**GENERAL**

The following changes are effective immediately and shall be incorporated in the Contract Documents.

Project Name: **PRESCOTT RECREATION COMPLEX**  
 Drawing No.: **D-2**

- .1 Erect temporary barriers to protect coatings during drying and curing.
- .2 Lock gates to prevent use until acceptance by the Consultant.

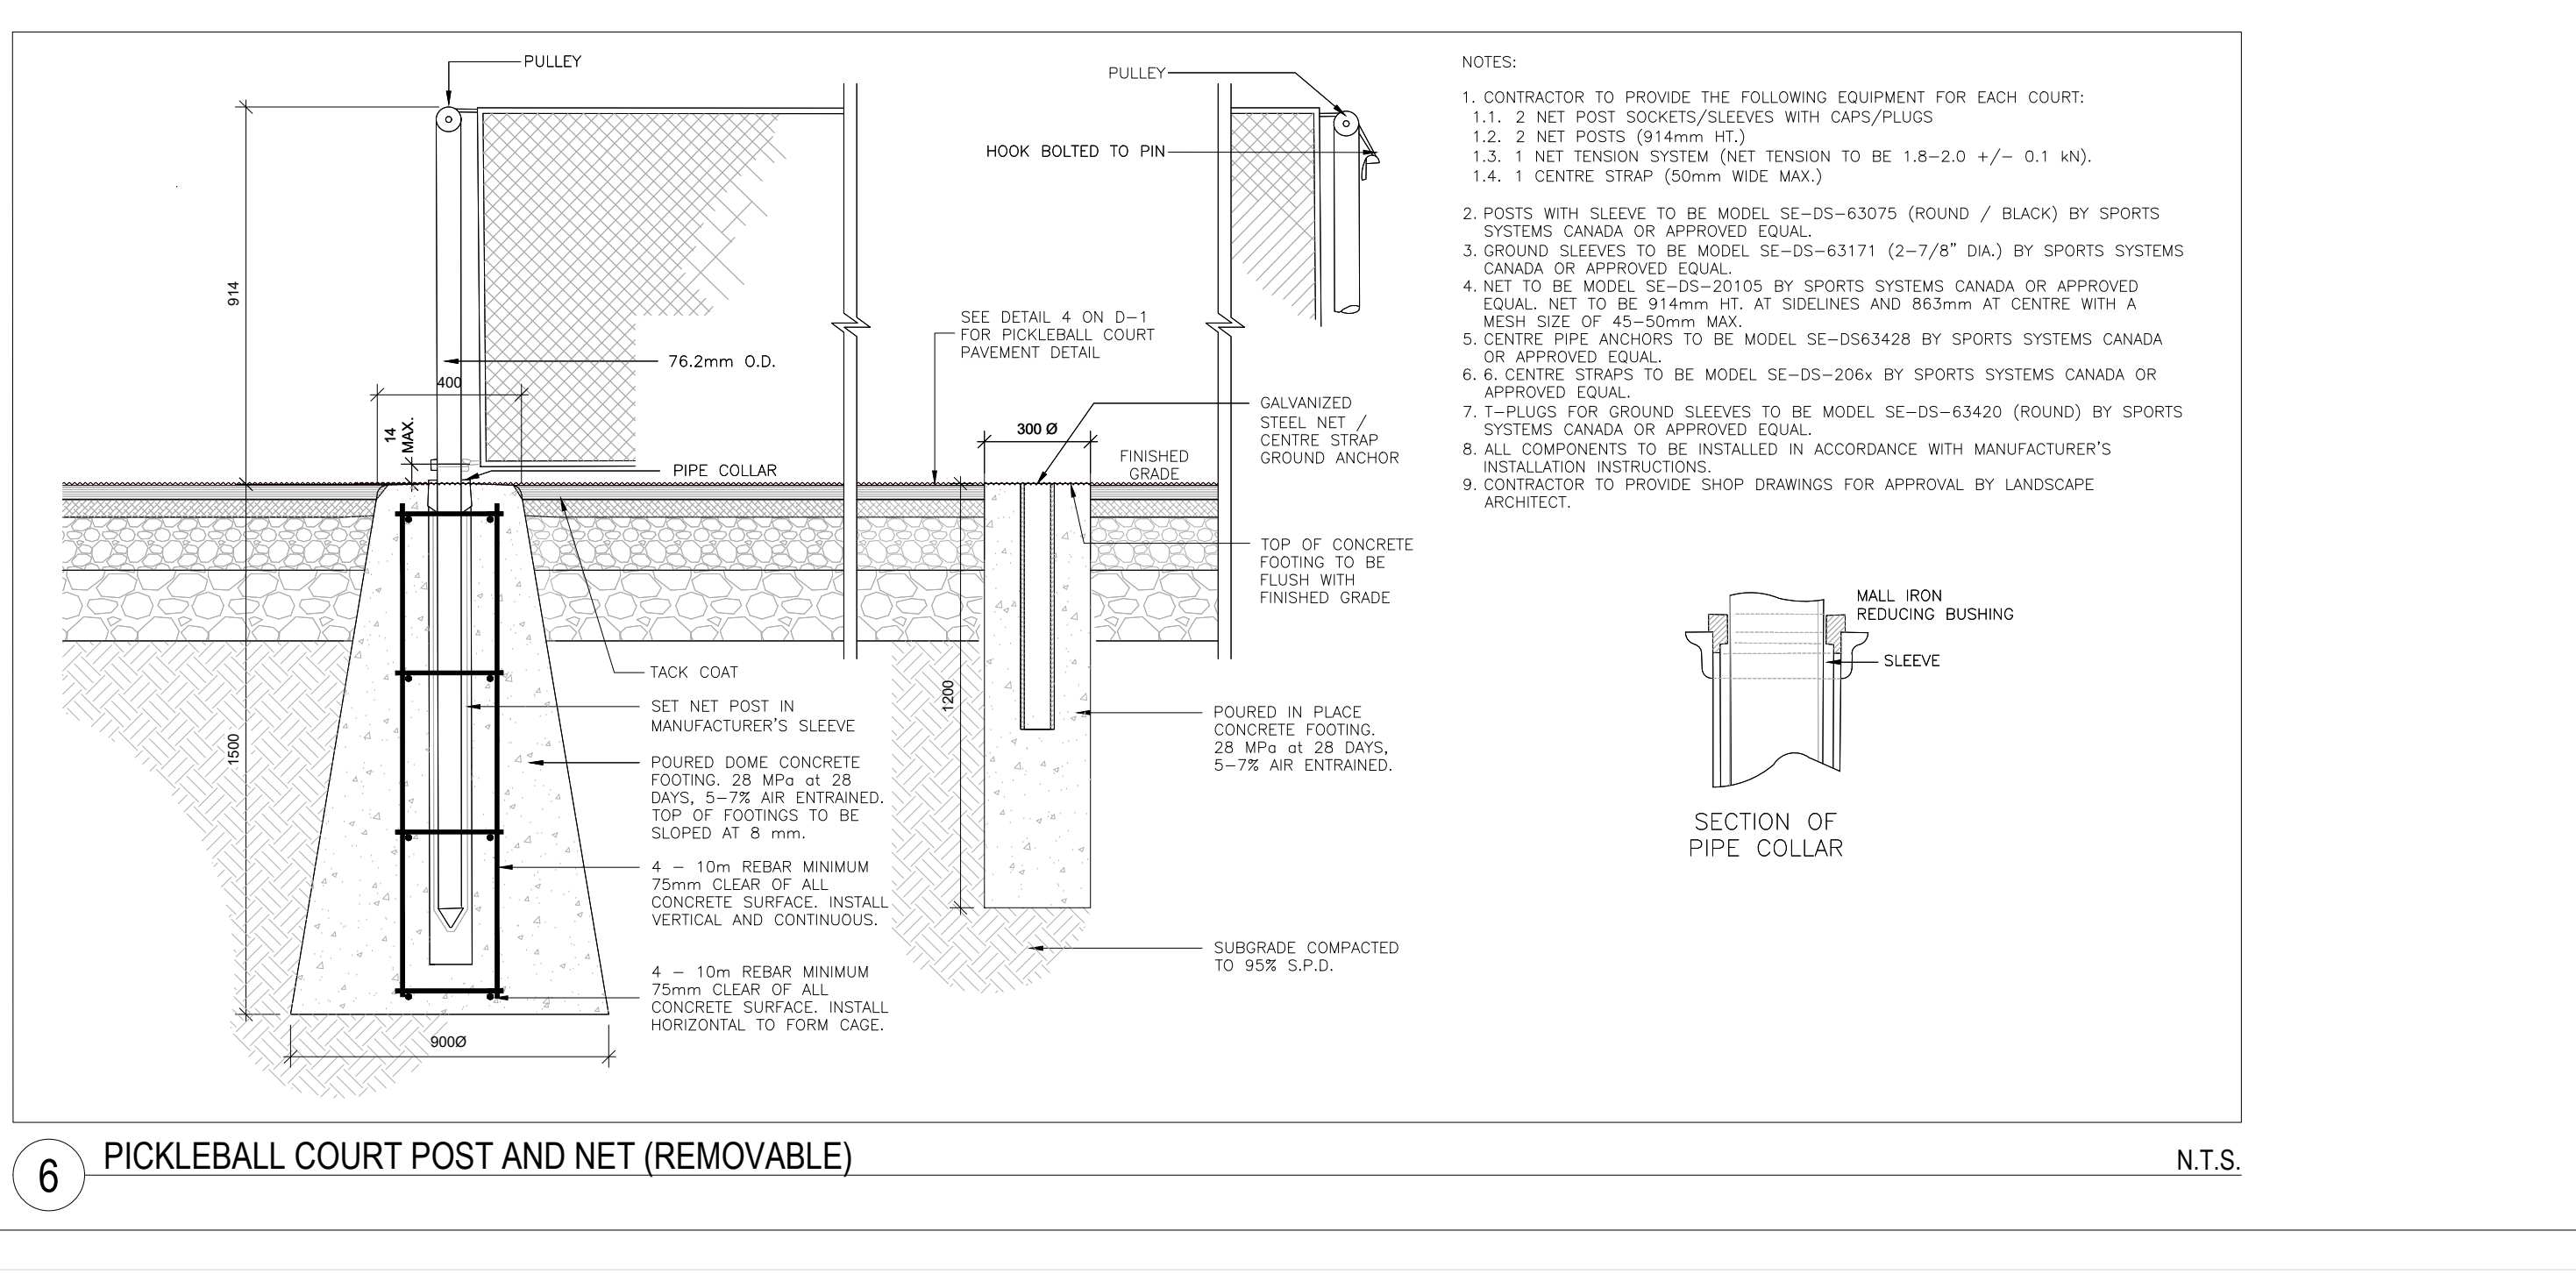
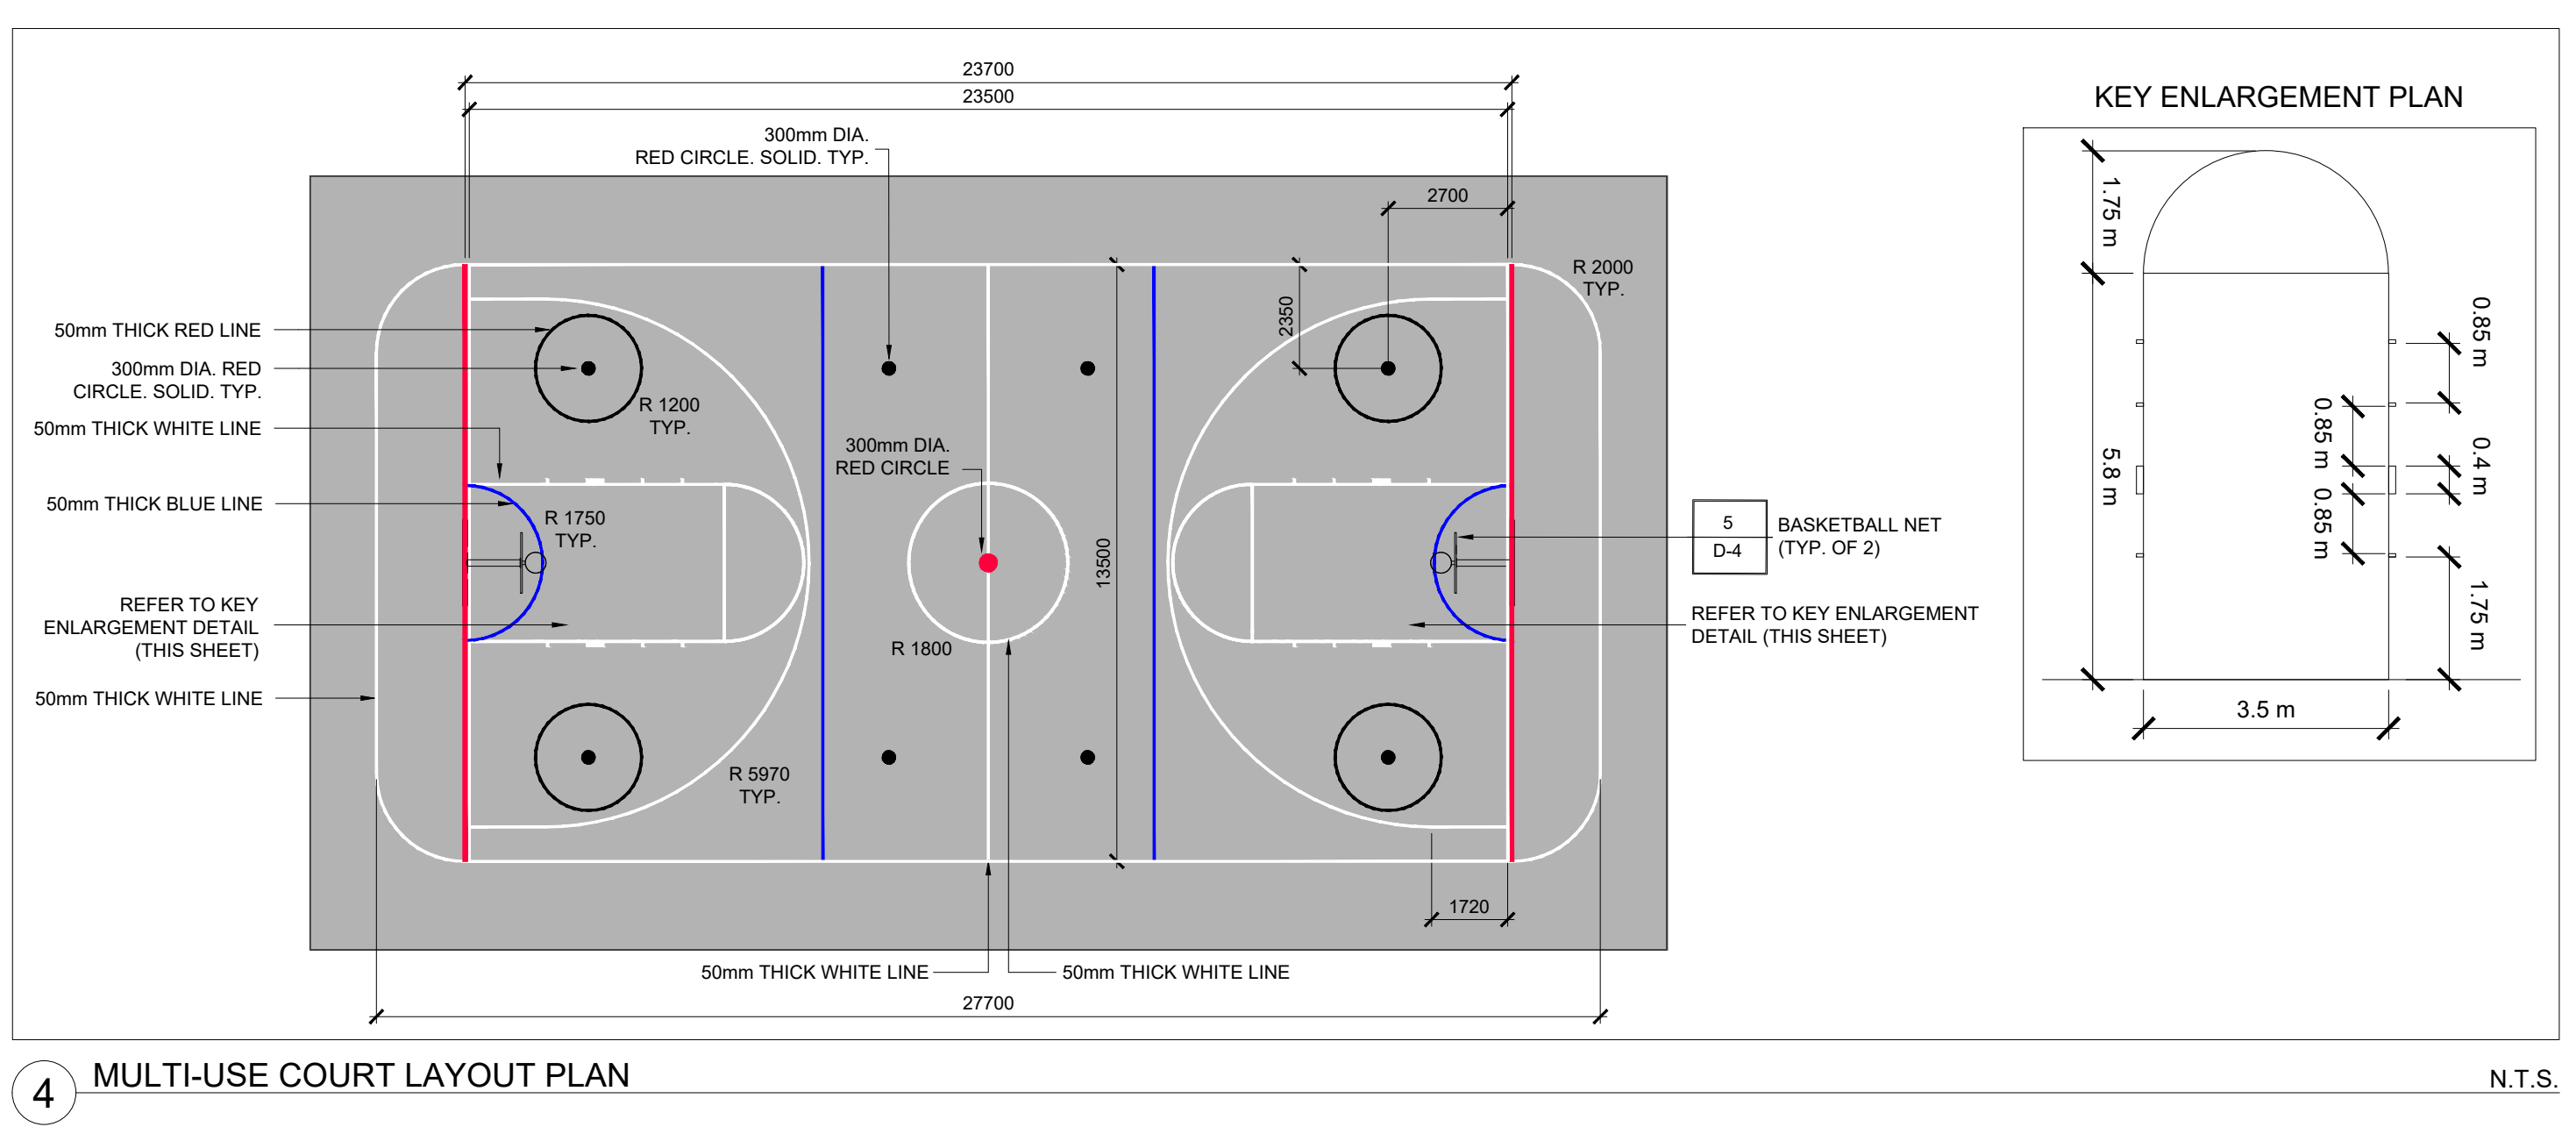
1. Drawing C1.1 – Site Servicing Plan
  1. Change Label on PECB2 to read:
    - T/G – 92.22m
    - INV. N – 91.34m
    - INV. S – 91.33m
    - INV. W – 91.53m
2. Drawing D-2 – Sports Court Details
  1. Modify detail 1 – Tennis/Pickleball Courts – Layout Plan as per attached updated drawing D-2.
